CASE 13-T-0469

**DPS Staff Interrogatories DPS-001 to DPS-027 with
Central Hudson responses.**

Central Hudson Gas and Electric Corporation

**A&C REBUILD PROJECT - ARTICLE VII APPLICATION
Case 13-T-0469**

| DRAWING NUMBER: EX. 8-04 | |

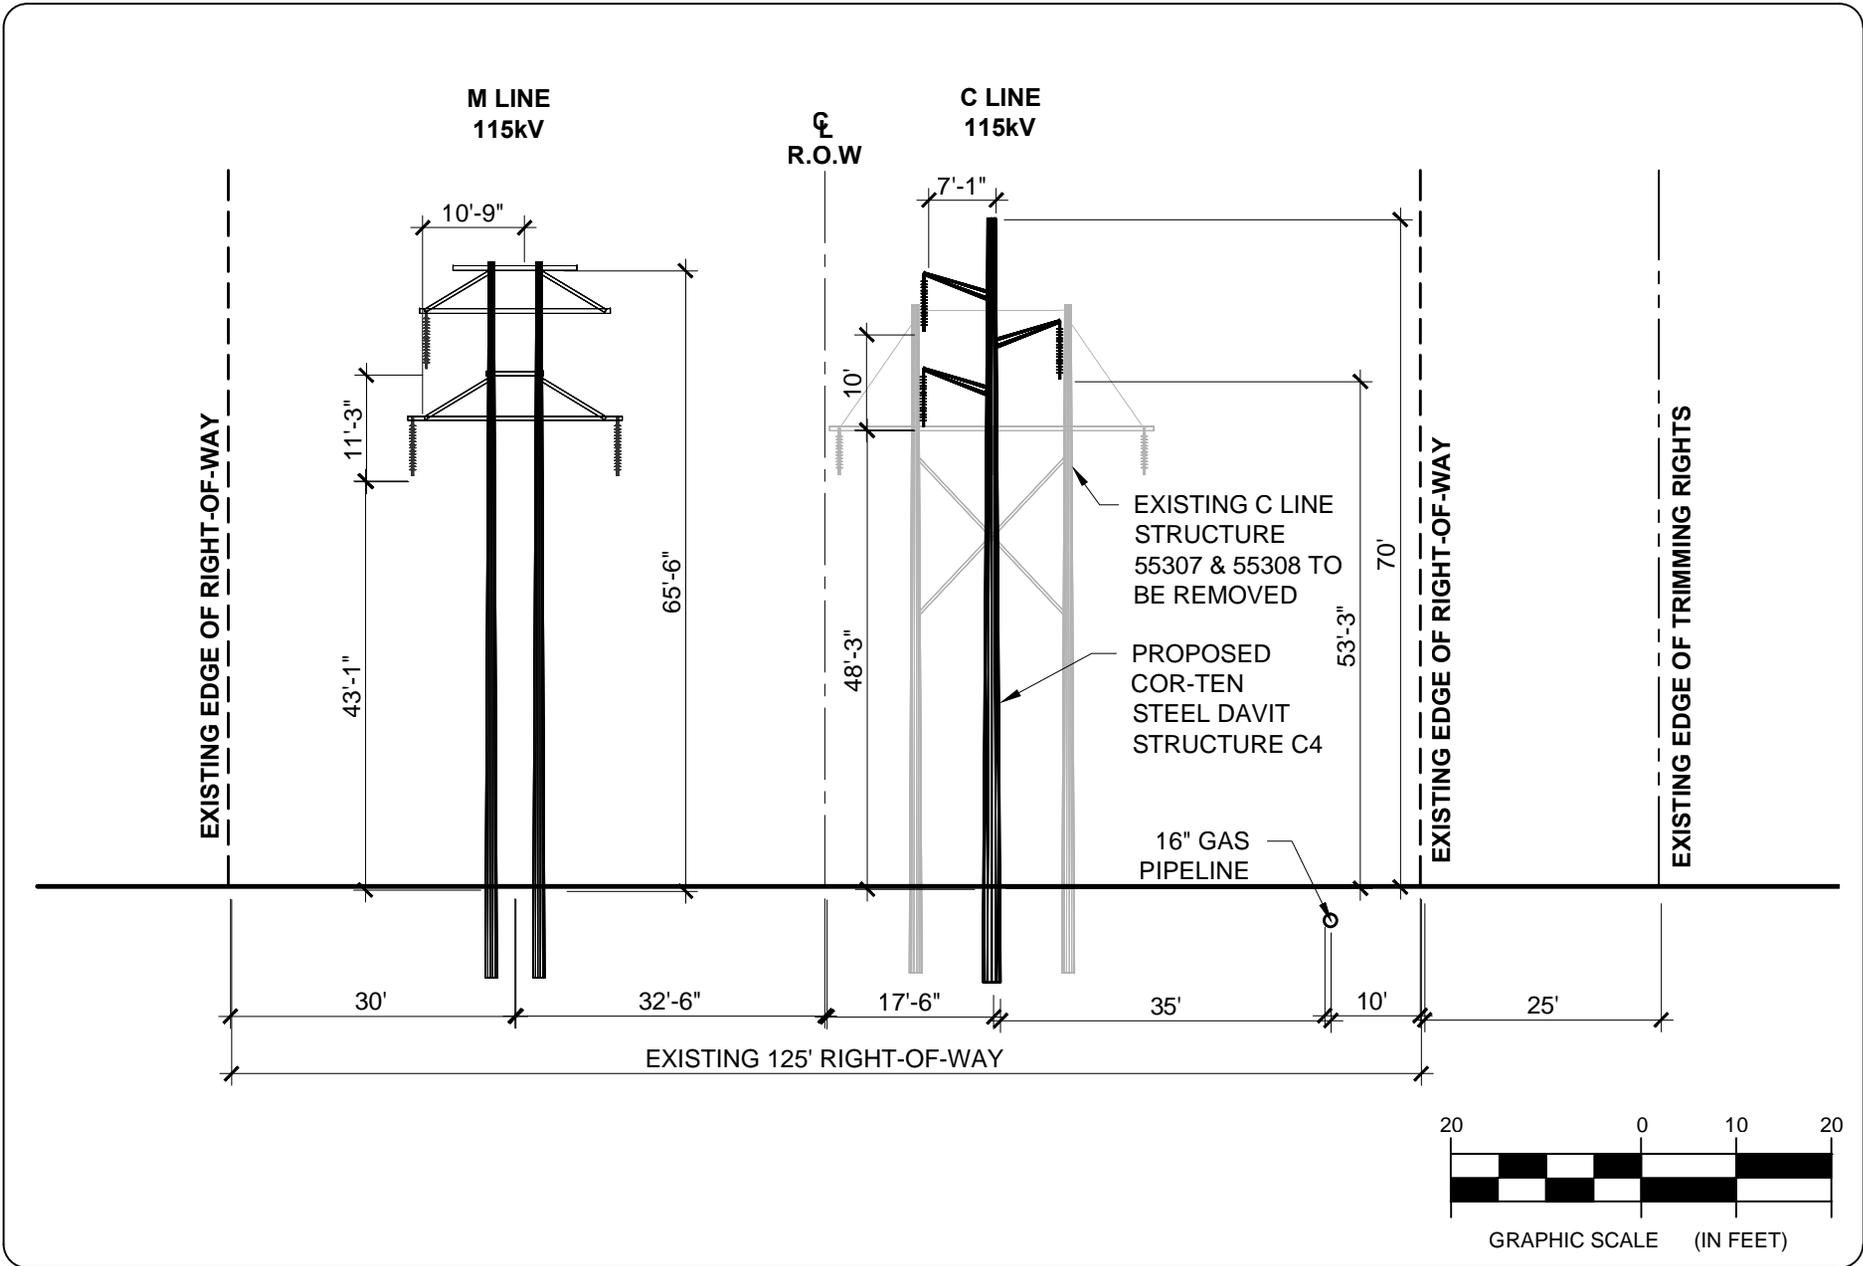
10. There appears to be a gas pipeline at Plass Road. This pipeline is not shown on any project drawings. Supply an updated look-down sheet(s) showing its location on the project ROW.

10. We understand that this question relates to Exhibits 8-04 and 8-05 attached to Central Hudson's January 13, 2014 filing. Revised Exhibits are attached as **Exhibit D** to this Response to show the referenced gas line (which is shown on the profile sheets contain in Appendix A to the Application, Sheet 1).

A & C 115KV LINES
EMF R.O.W. CROSS SECTIONS
SHEET 1 OF 8

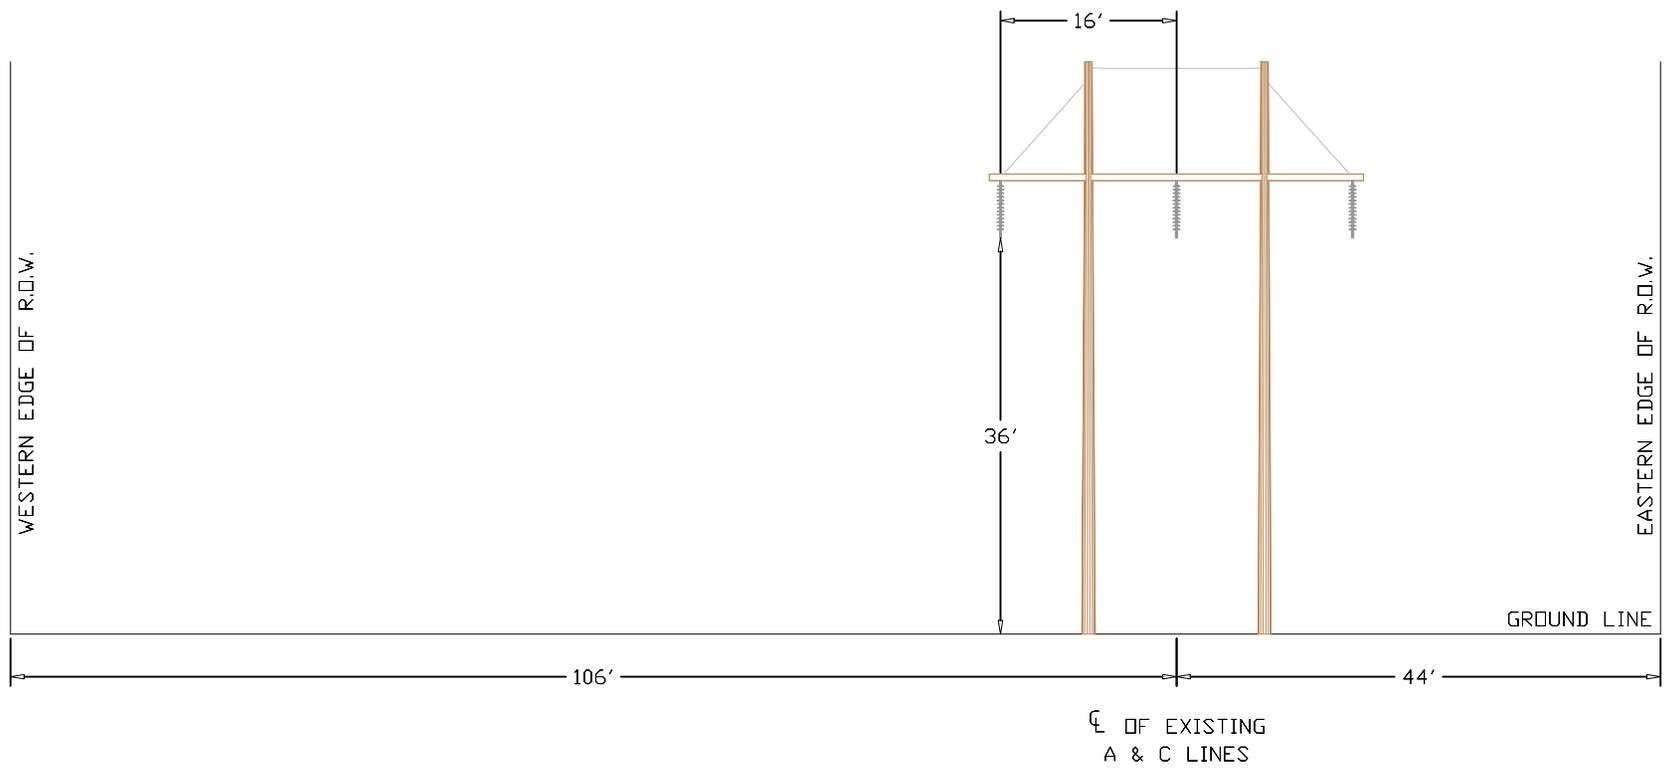
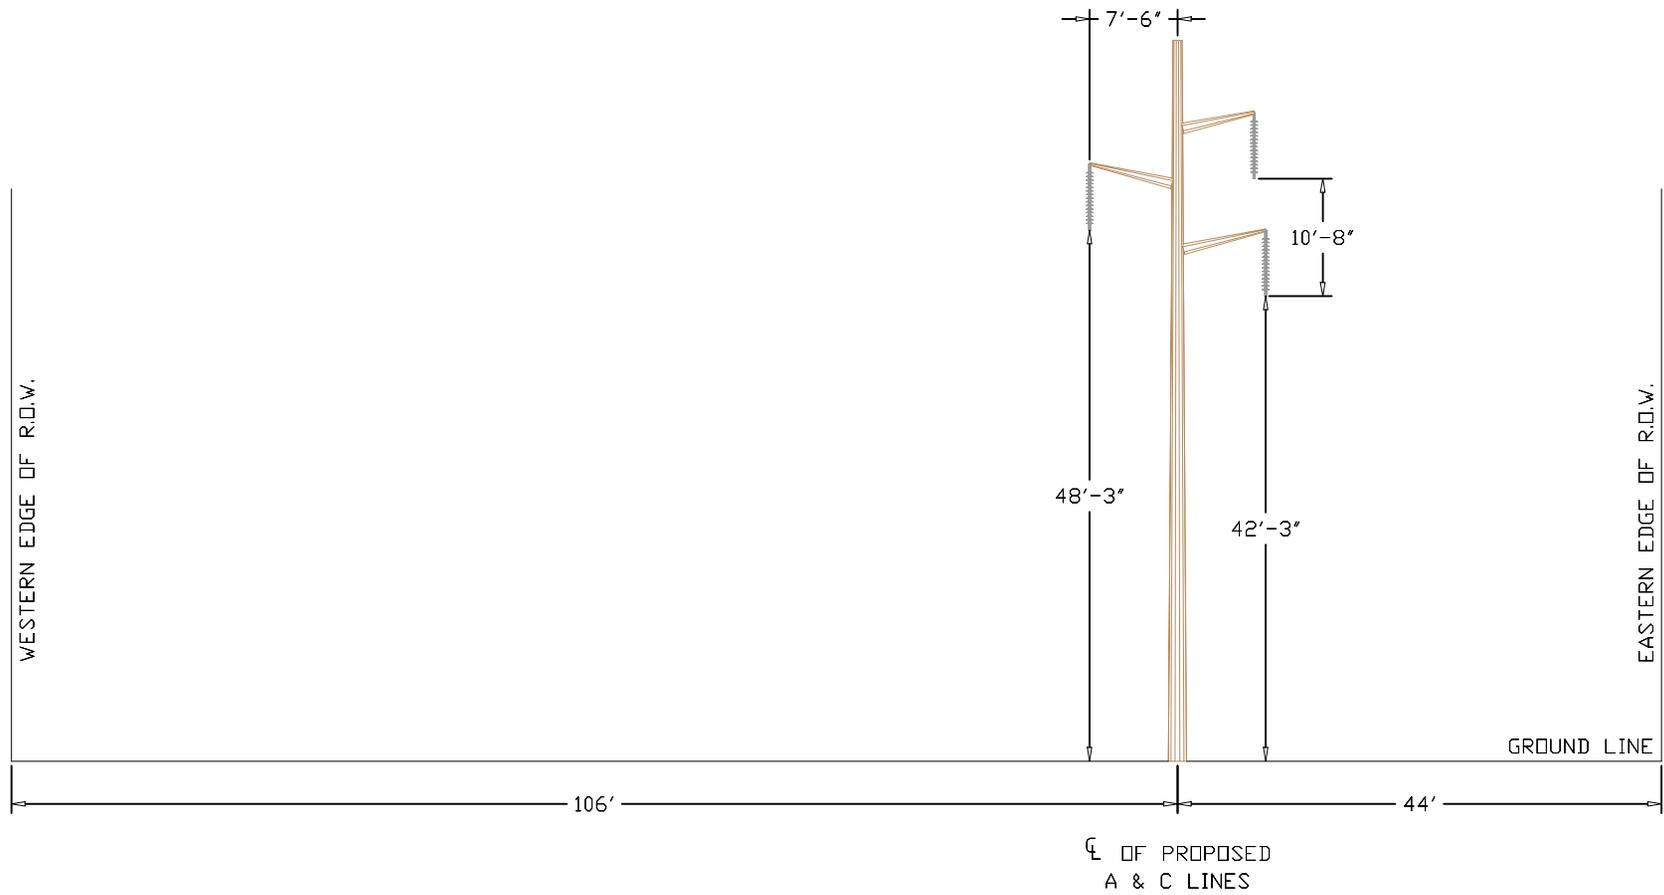
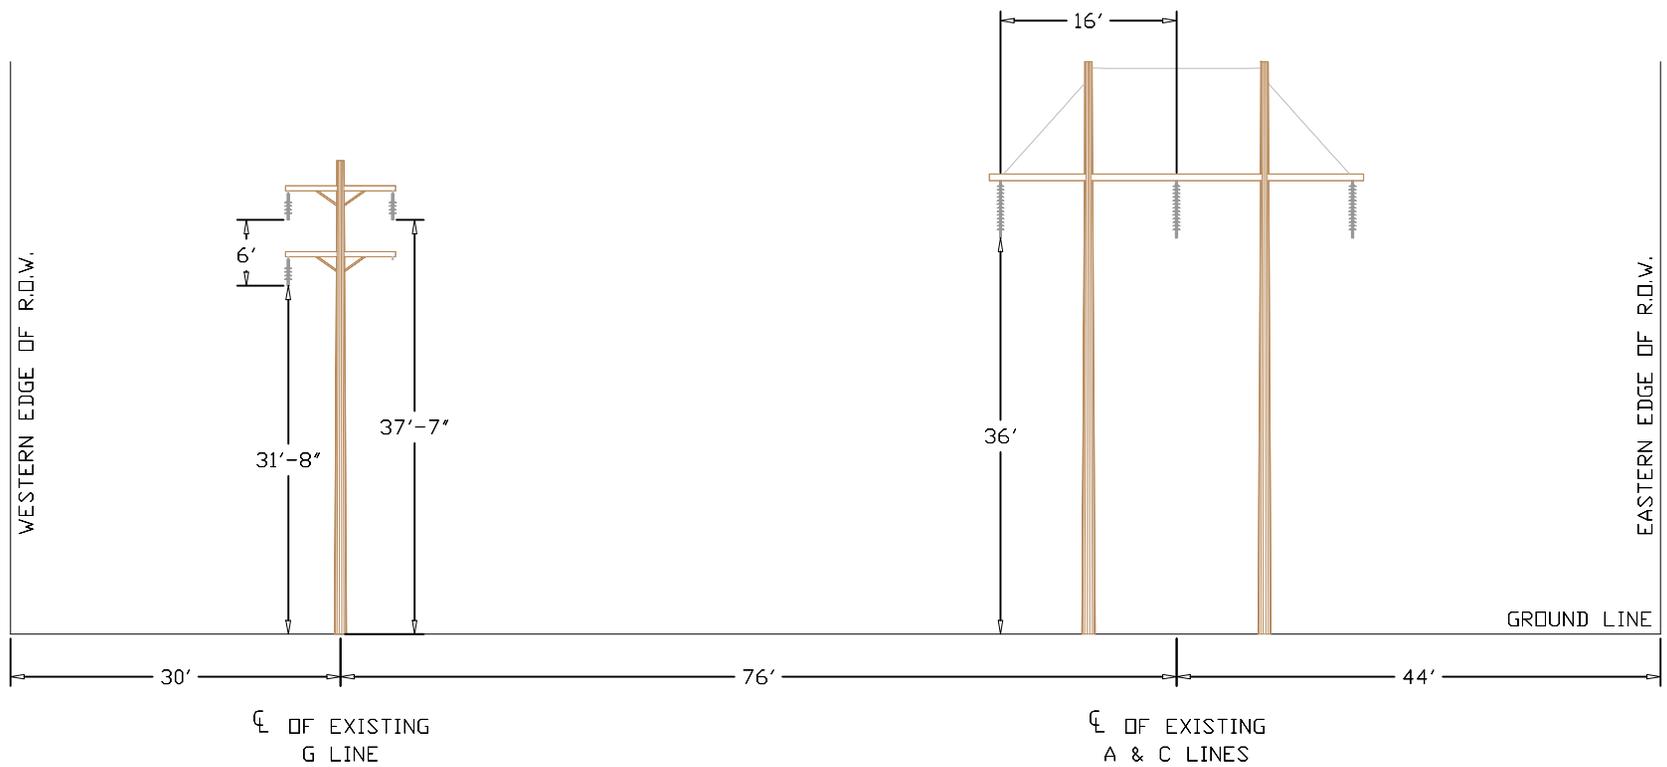
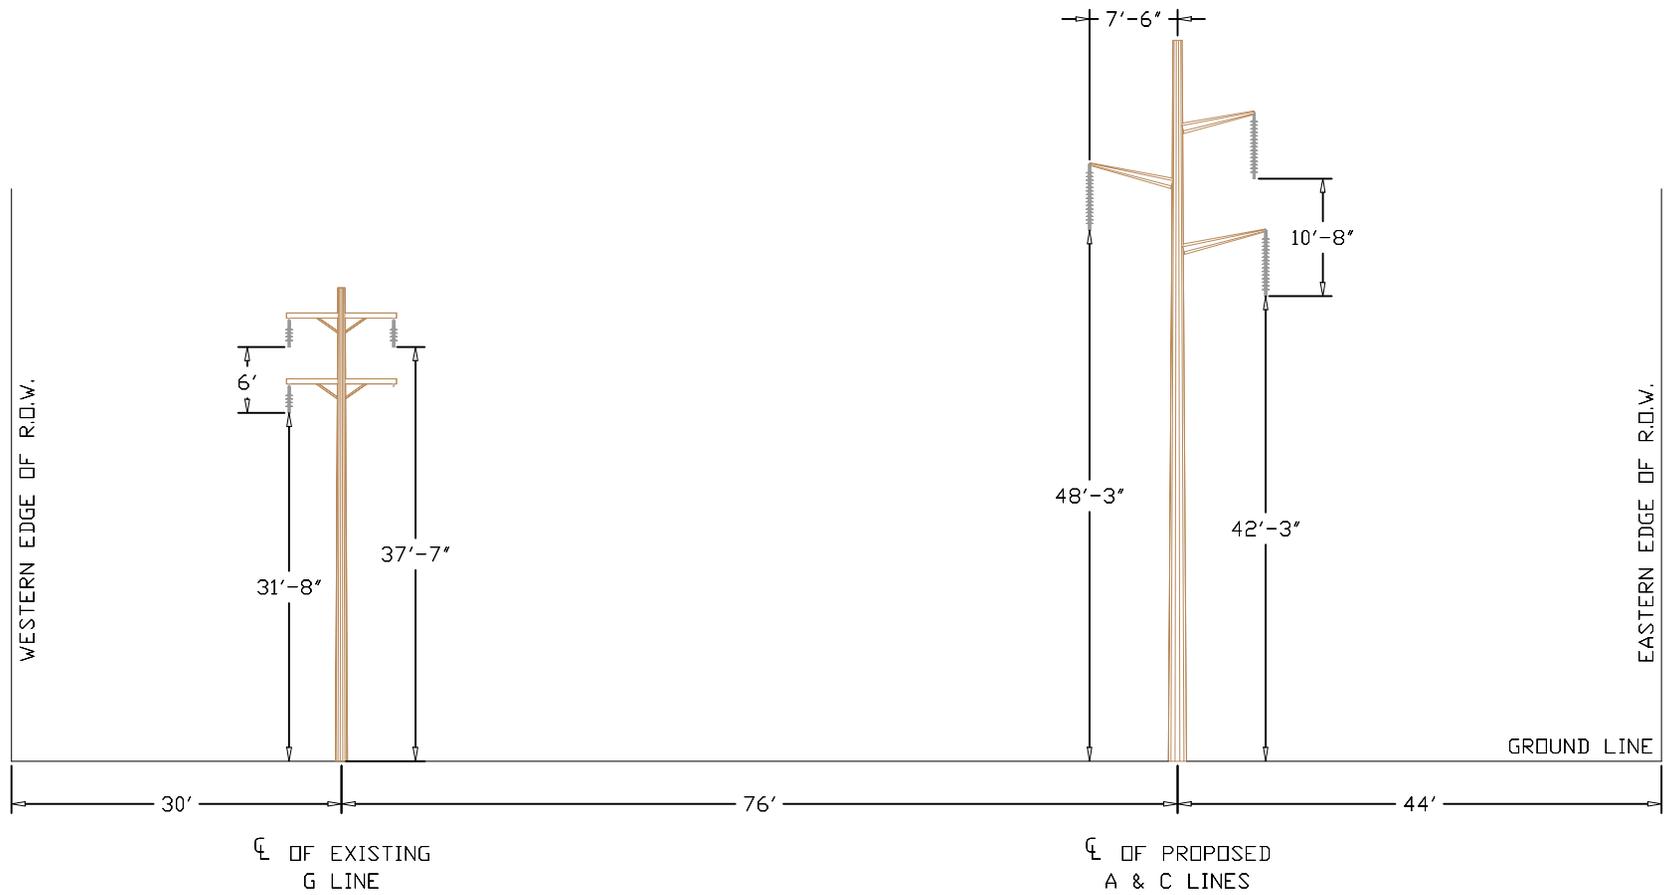
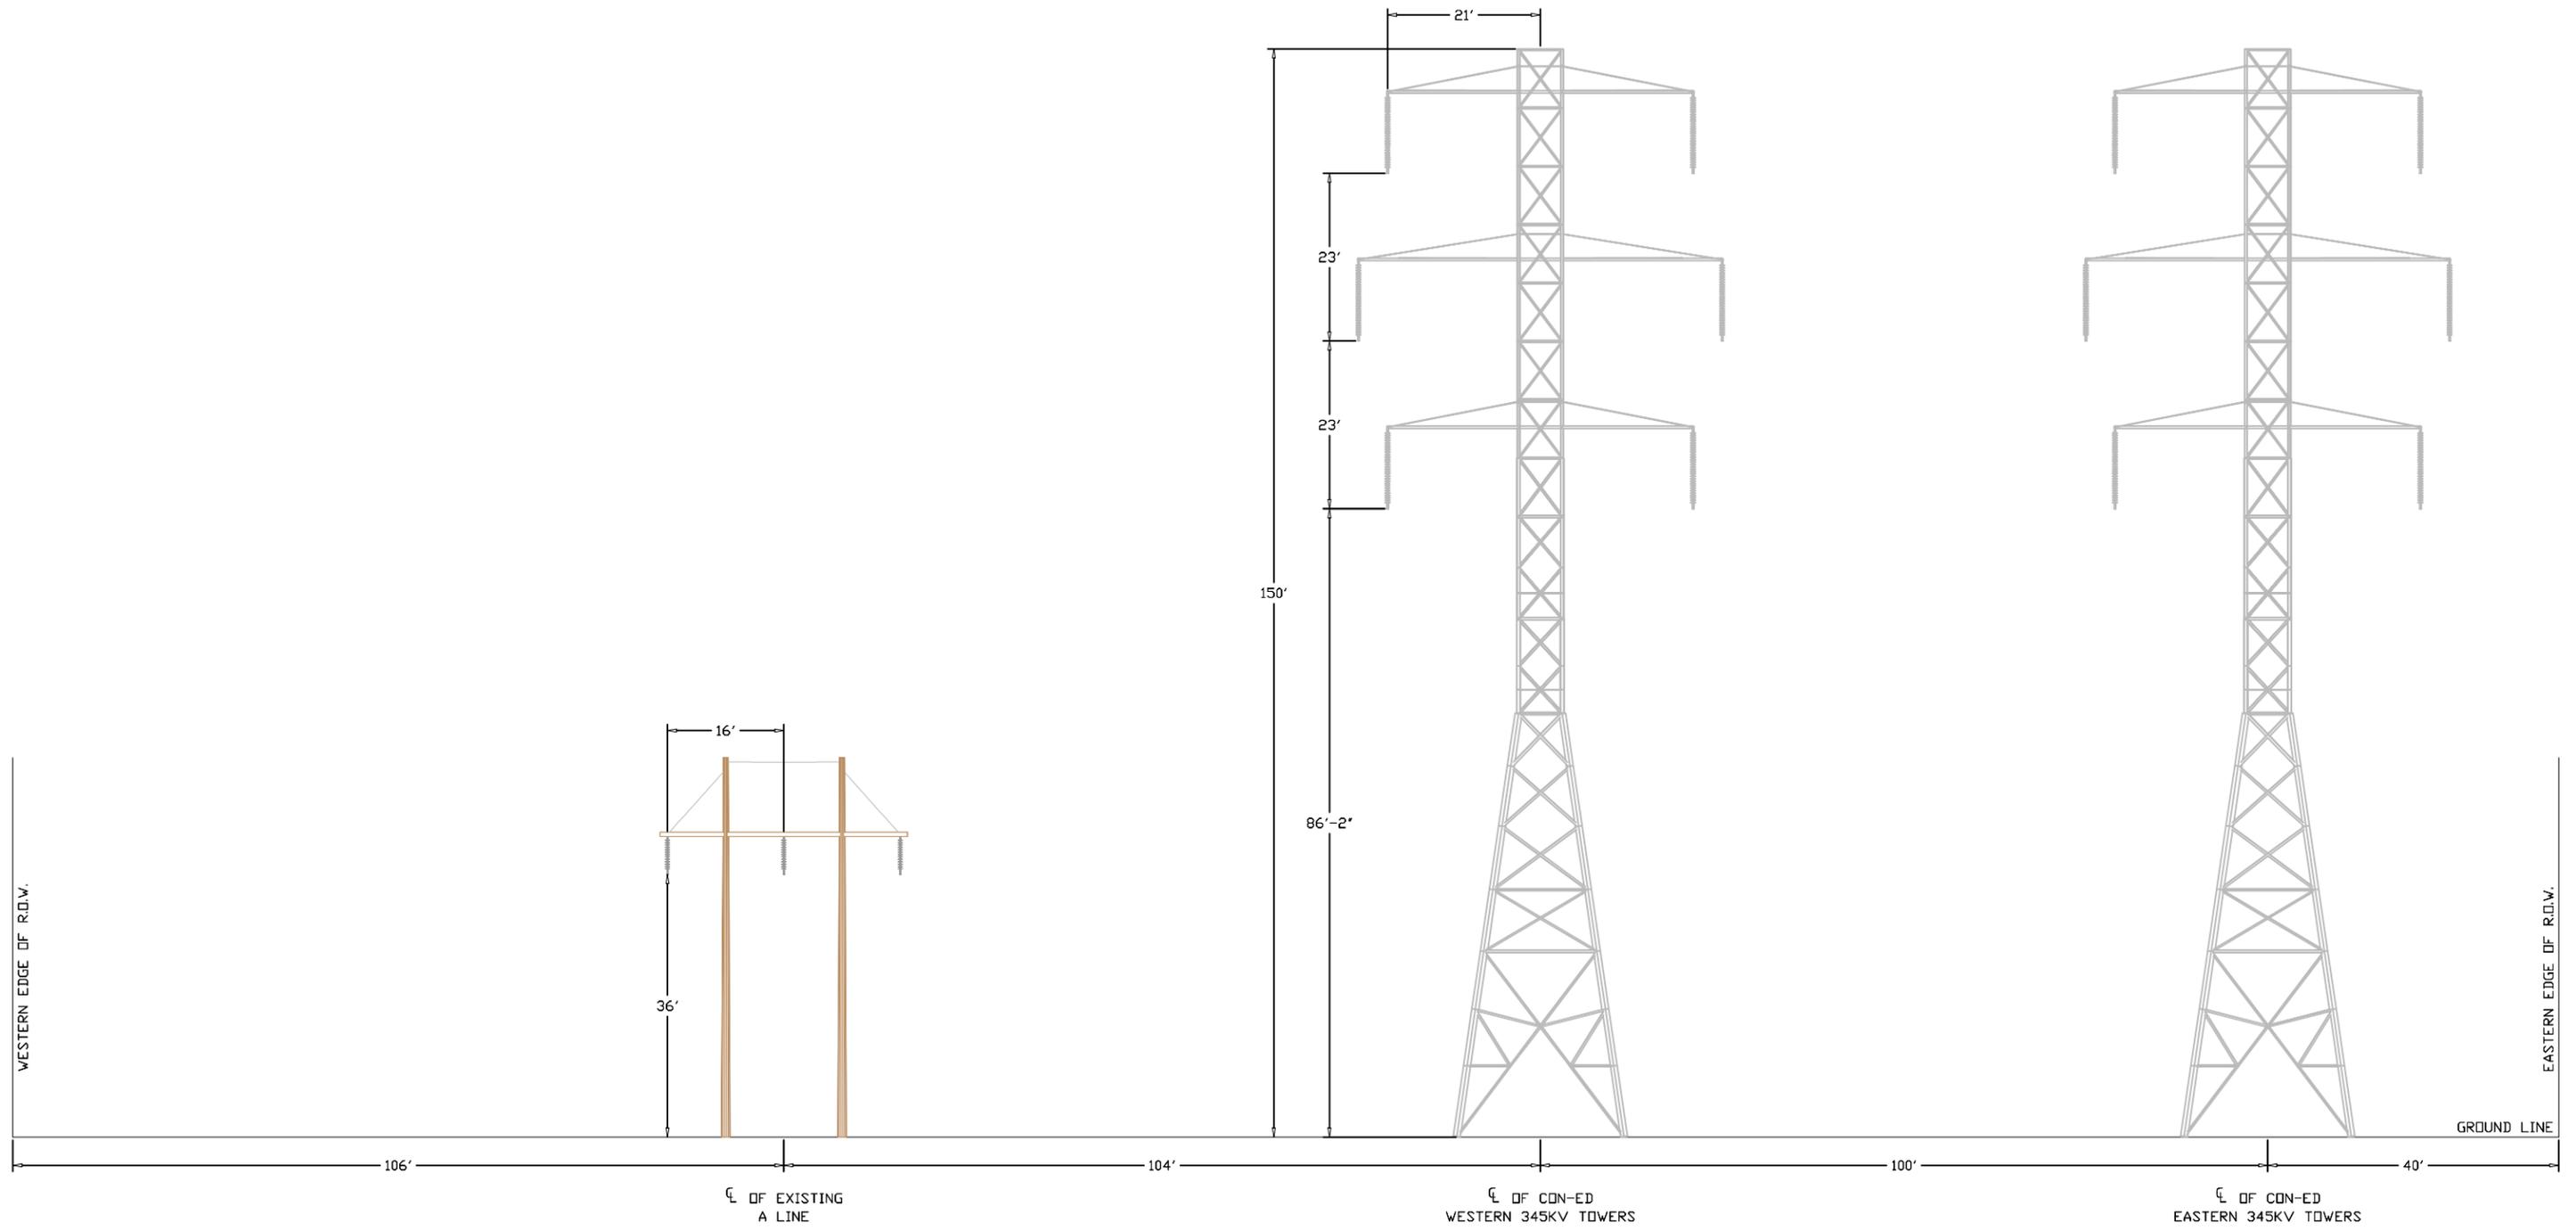
Provide the engineering drawings for the Consolidated Edison-owned lines and the Central Hudson Gas and Electric Corporation-owned A&C lines used to calculate the EMF levels that were provided in the Application for various portions of the right-of-way (ROW). The drawings should be to scale and include the dimensions of the structure and spacing of the conductors and ground wires.

The drawings used to calculate the EMF levels are the cross-sections (8 sheets) attached as **Exhibit A** to this Response.
